DESIGN <i>CP</i>	DRAWN BY <i>CP</i>	DART AEROSPACE LTD HAWKESBURY, ONTARIO, CANADA	
CHECKED <i>#</i>	APPROVED <i>#</i>	DRAWING NO. D3016	REV. A SHEET 1 OF 3
DATE 01.05.18		TITLE SEAT FRAME ASSEMBLY	SCALE NTS
A	01.05.18	NEW ISSUE

DRAWING NO. D3016	TITLE SEAT FRAME ASSEMBLY	REV. A	DART AEROSPACE LTD ENGINEERING ORDER	D.E.O. NO. D3016-A-1	SHEET NO. SHEET 1 OF 1	SCALE NTS
DRAWN 1	CHECKED UP	MFG. APPR. BE	APPROVED WAP	DE APPR. TH		
DATE 10.01.29	DATE 10.01.29	DATE 10.01.29	DATE 10.01.29	DATE 10.01.29

TO REVISE D3016-11 SADDLE'S HOLE SIZES

D3016-11 SADDLE

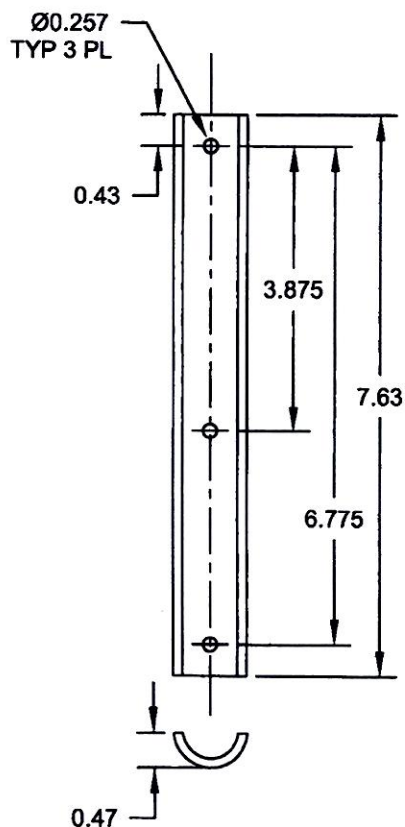
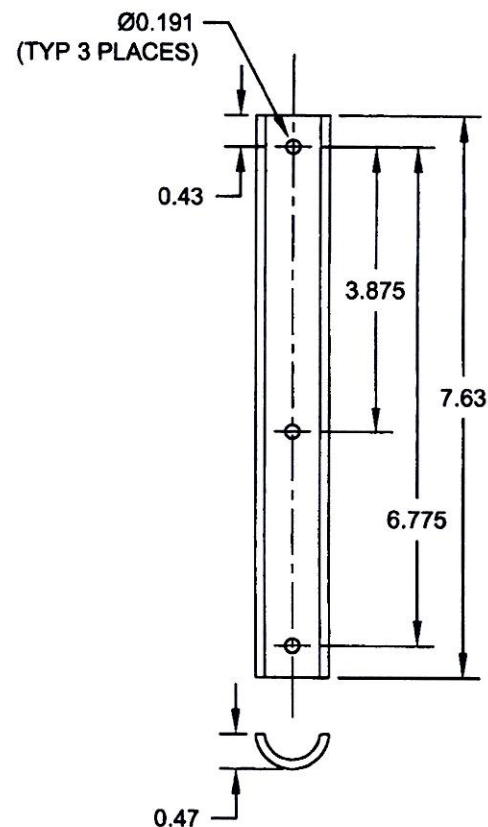
DETAIL D3016-11 SADDLE (SHEET 3): Ø0.257 TYP 3 PL WAS Ø0.191 (TYP 3 PLACES) AS SHOWN:
